**KAWARTHA PINE RIDGE DISTRICT SCHOOL BOARD**  
**PUR25-049-ITT**  
**Enniskillen Public School Refresh – Phase 2**

**ADDENDUM NO. 3**

# Enniskillen Public School Renovation

**Addendum #:** E-1**Revision #:** 0

FIGURE NUMBER:  
HM-01

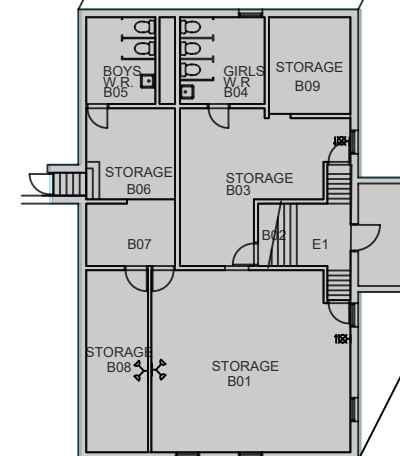
- .1 DRAWING HM-01 – Asbestos Specifications
  - .1 Classroom 01 (Loc. 10) and Classroom 02 (Loc. 9) have been removed from the assessed area.
  - .2 Presumed asbestos-containing floor mastic in Classroom 114A (Loc. 33) and Classroom 114B (Loc. 32) has been removed from the drawing.
  - .3 Clarifies asbestos containing drywall joint compound to be abated in Classroom 143 (Loc. 28), Corridor (Loc. 25), and Classroom 114B (Loc. 32).

Reflected Ceiling Plan,  
Door & Window Schedule

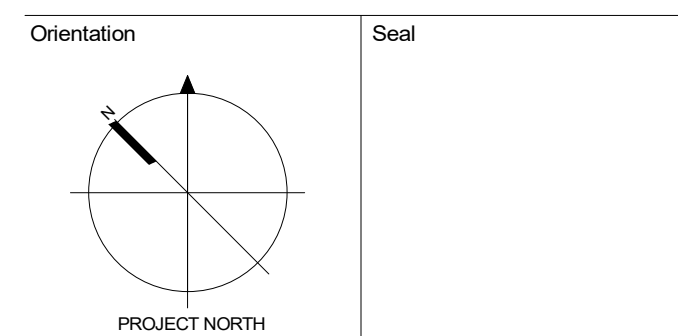
D114C and D11D note to modify existing frame to suit new door height. Can you please provide more details, is the glazing to be replaced and what modifications are to be made?

Please refer to Architectural Addendum 02. A601 now includes an elevation with notes to clarify.
